CITIZENS FOR RESPONSIBLE DEVELOPMENT

RESPONSE TO VALOR DEVELOPMENT'S DESIGN REVIEW APPLICATION ZC CASE 16-23

January 24, 2019

View from Windom Pl. – DDIS Model of Revised Design

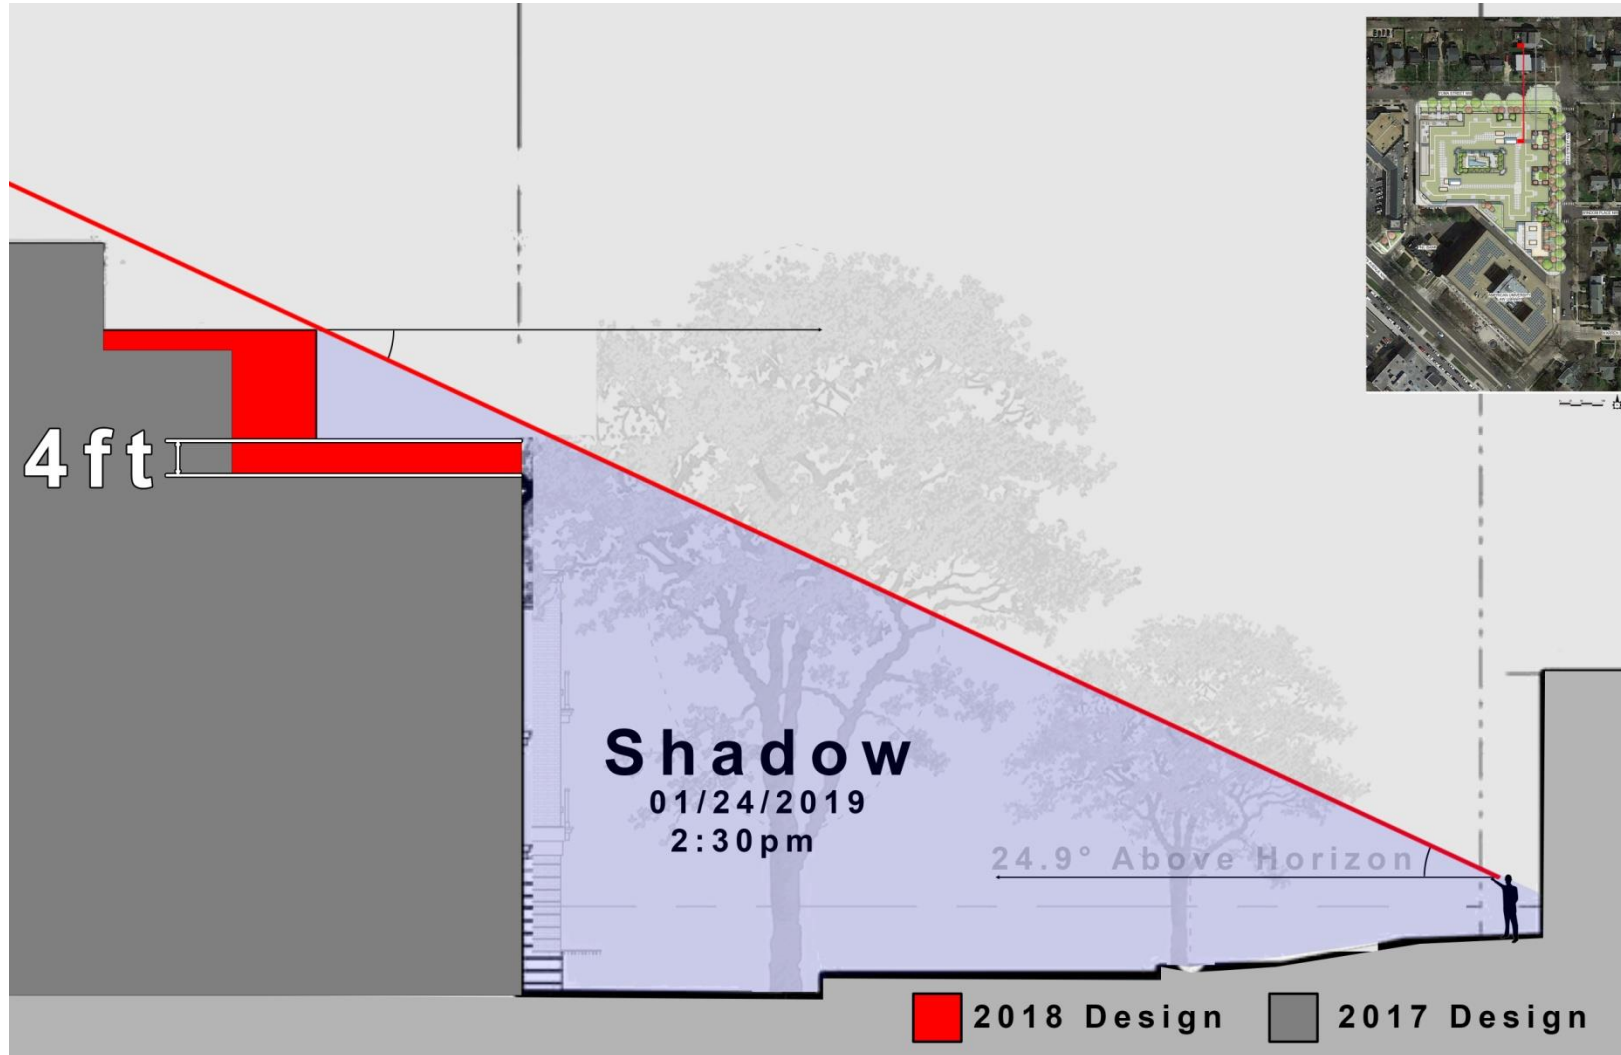
10-16-2018 “New” design as seen from Camera Loc. 01. The 3D model-massing accurately represents the height and width of the proposed development from this Windom Pl perspective .

Greater Visual Impacts:

2017 Design vs. 2018 Design: Visual Impacts on Nearby Neighbors

The nearest sections of the building have increased in height by 4ft, and portions of the penthouse now protrude further East (and North along Yuma), which makes them closer and taller. This increase in height along the perimeter of the building negates the proposed decrease in height at the building's center with regards to the nearby neighbors.

Viewshed diagram - "CL07 Alley View"

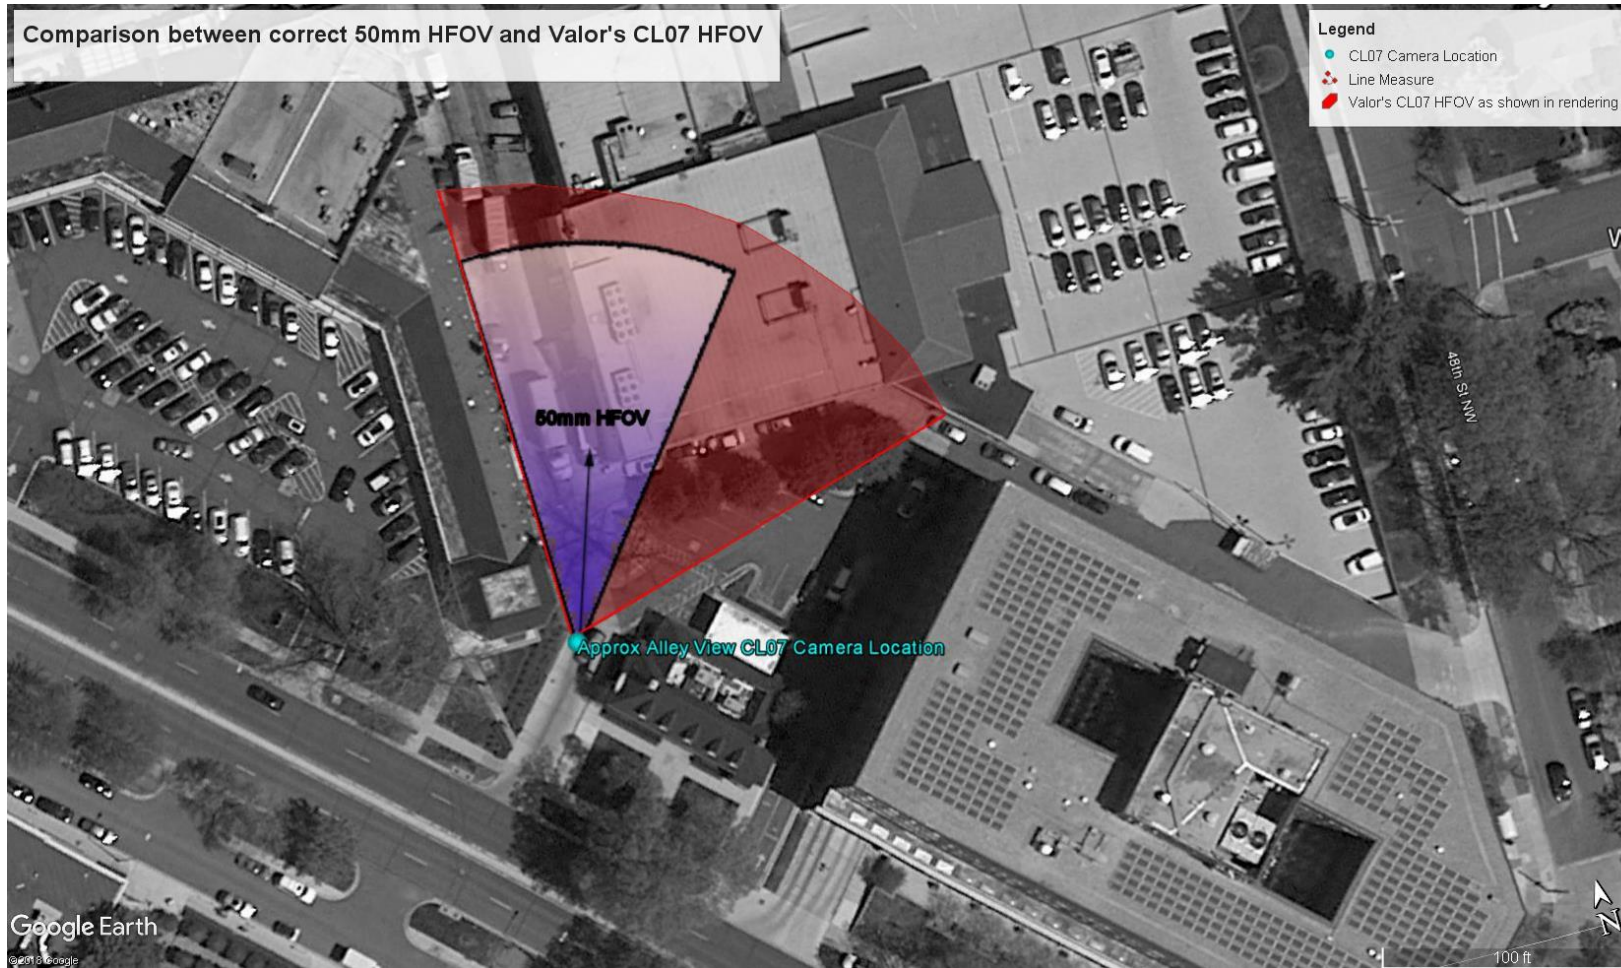
This graphic compares a true 50mm's horizontal field-of-view (Blue HFOV)(39.6°) with the actual Red HFOV portrayed in Valor's CL07 rendering. Note the dramatic difference between the two. While the rendering is labeled as a 50mm, it is clearly much wider. It is likely a 24mm lens. Using a wide-angle lens inherently reduces the visual impact of the proposed development by shrinking the building.

Side-by-Side Comparison Views of Windom Pl.

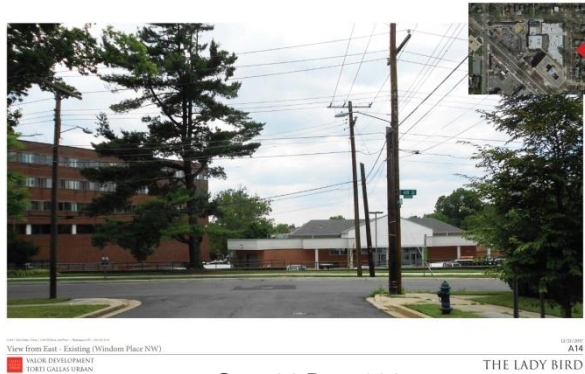
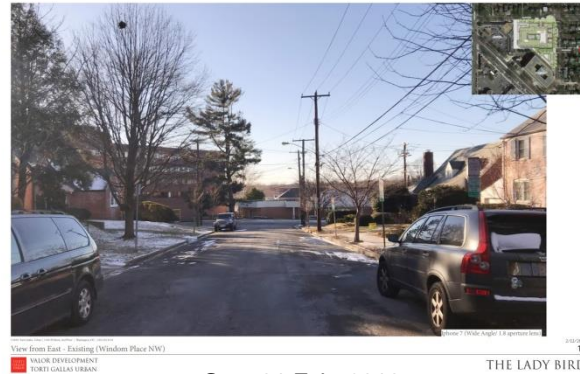
Evolution of the Lady Bird Development design, as portrayed by Valor over time. Notice the disorienting effect of changing camera locations and perspectives. With each generation, the camera location moves further away from the proposed development. Additionally, the camera lens and, therefore, the perspective changes with each version.

Cam 01 Dec. 2017.
Camera is approximately 125ft from property line.

Cam 01 Feb. 2018.
Camera is approximately 240ft from property line.

Cam 01 Oct. 2018.
Camera is approximately 300ft from property line.

Cam 01 Dec. 2017. "Proposed Conditions"
Rendering associated with above shot.
Entirely virtual. No real references.

Cam 01 Feb. 2018. "Proposed Conditions"
Rendering associated with above shot.
Building overlay on real image, but wide angle.

Cam 01 Oct. 2018. "Proposed Conditions"
Rendering associated with above shot.
Entirely virtual. No real references.

The Negative Impact of Camera Location/Perspective Shifts
Between Existing and Proposed Conditions: View from Yuma St, West of North/South Alley.

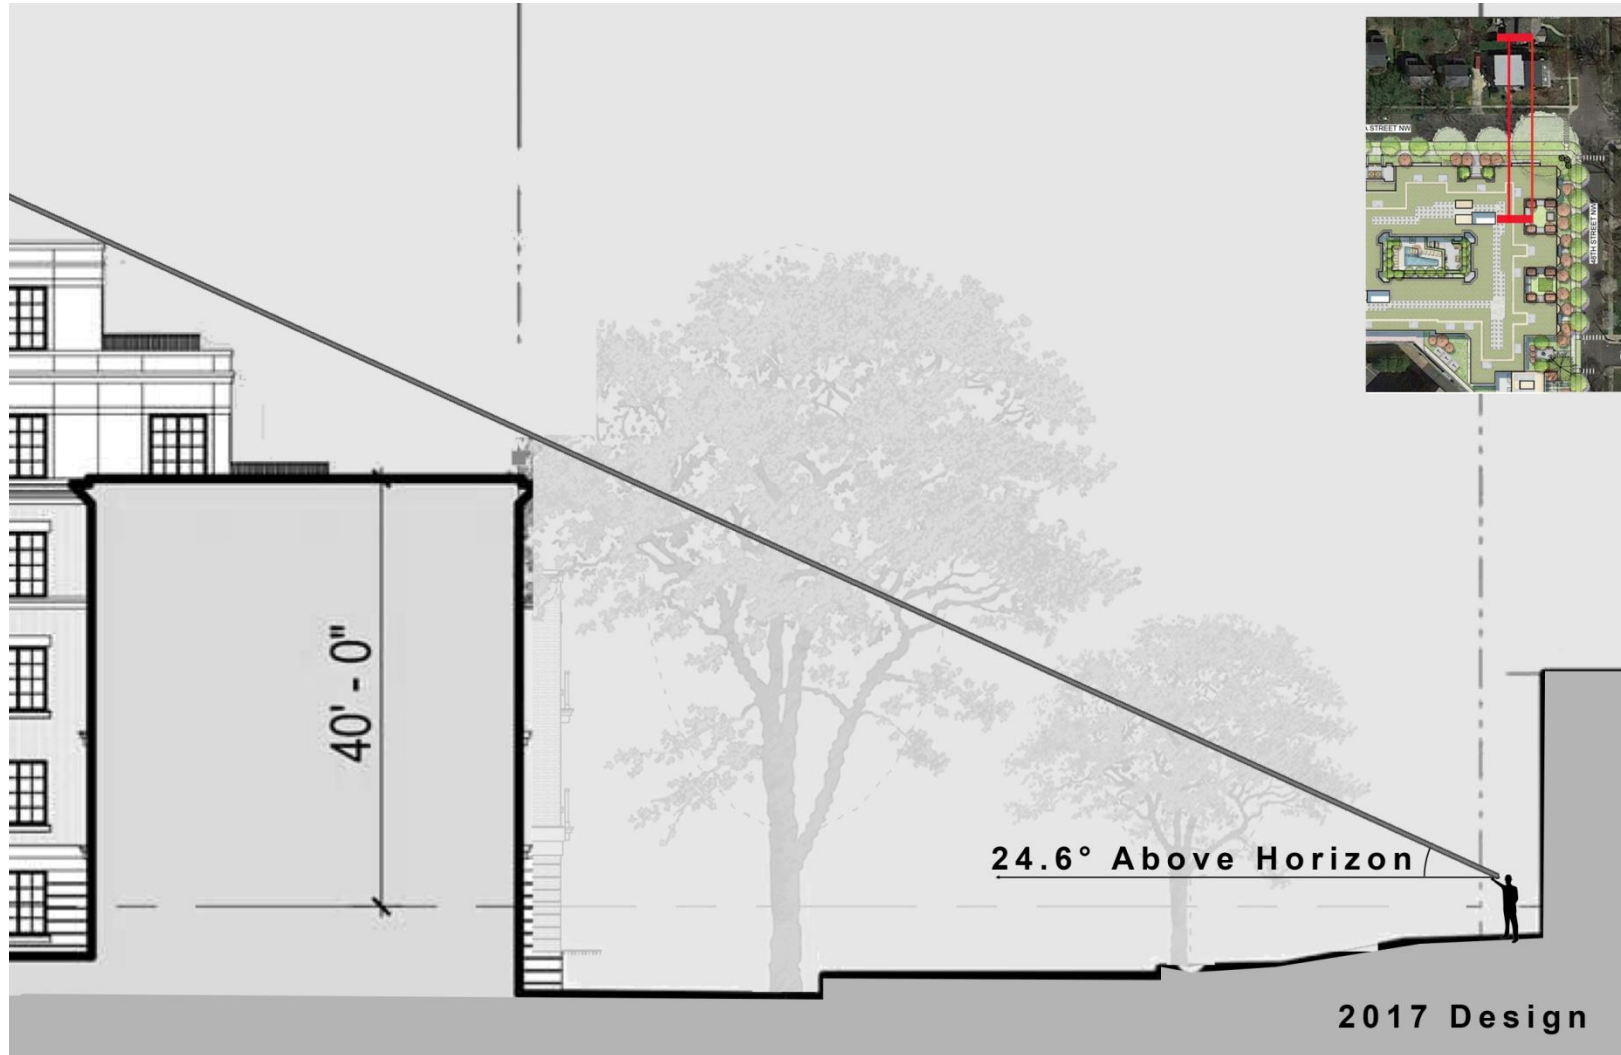
“Existing” Shot from Yuma St, West of the North/ South Alley.

This “Proposed” view is from an entirely different perspective. It appears to be from deep within the yard of one of the neighboring houses, as opposed to the street view presented above.

2017 Design vs. 2018 Design: Visual Impacts on Nearby Neighbors

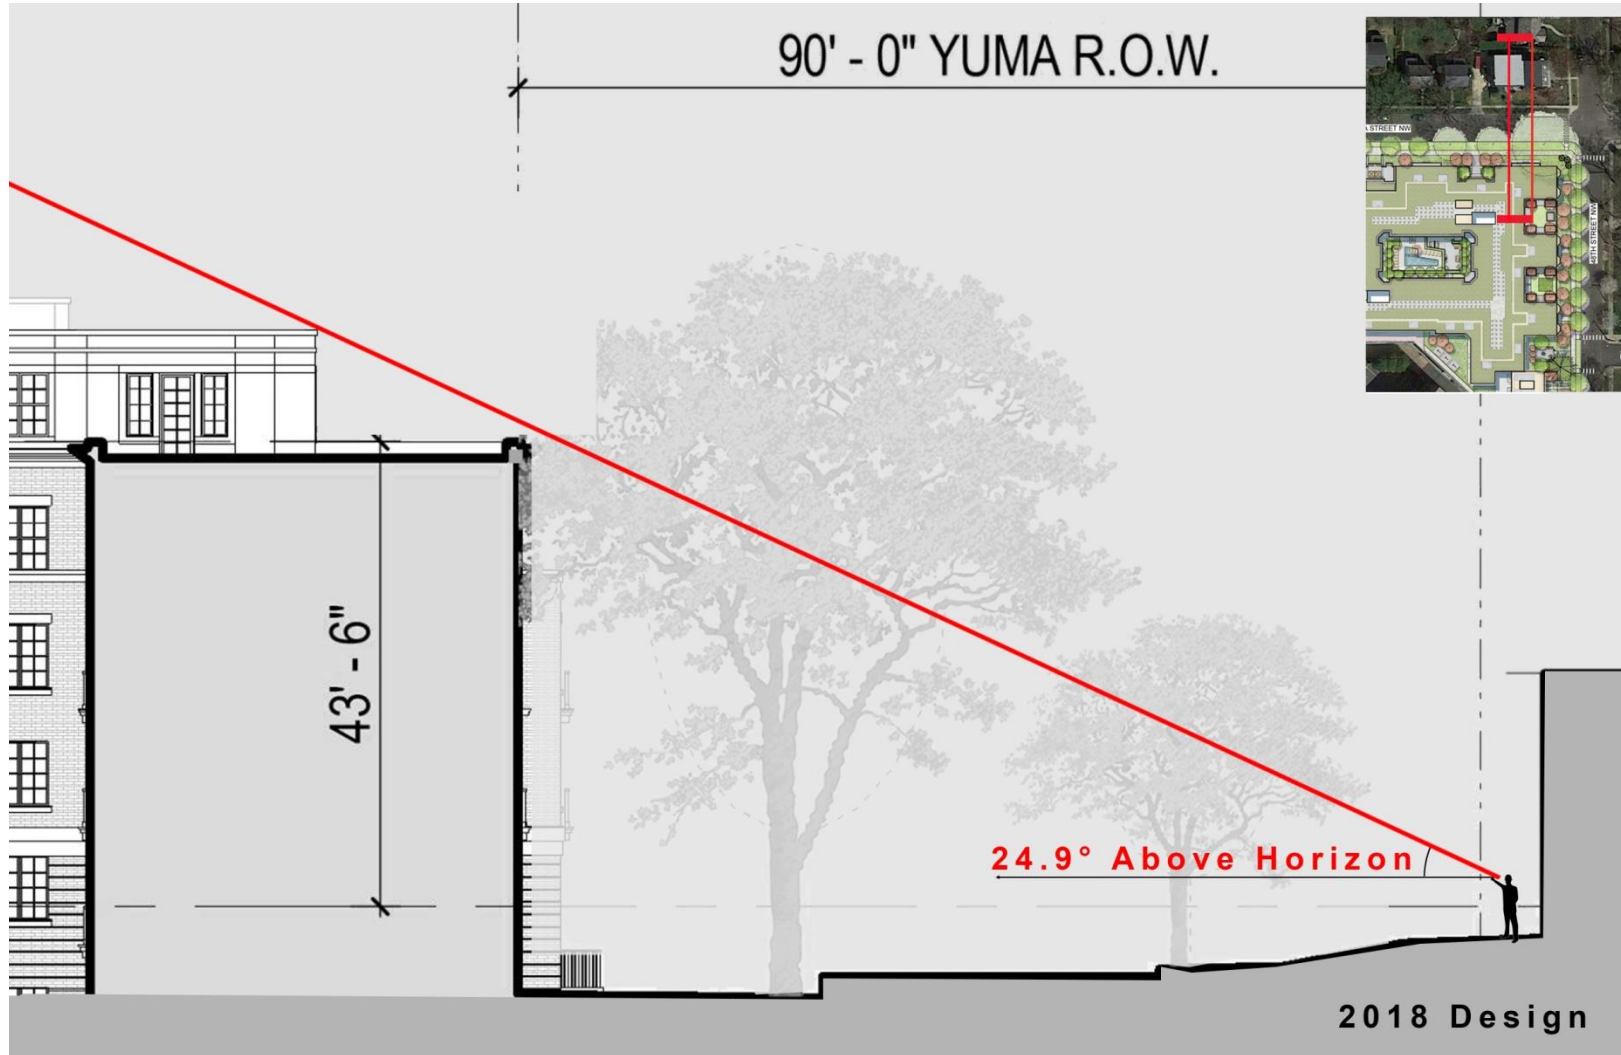
The nearest sections of the building have increased in height by 4ft, and portions of the penthouse now protrude further North toward Yuma and East toward 48th Street. Both changes makes them closer and taller . This increase in height along the perimeter of the building negates the proposed decrease in height at the building's center with regards to the nearby neighbors.
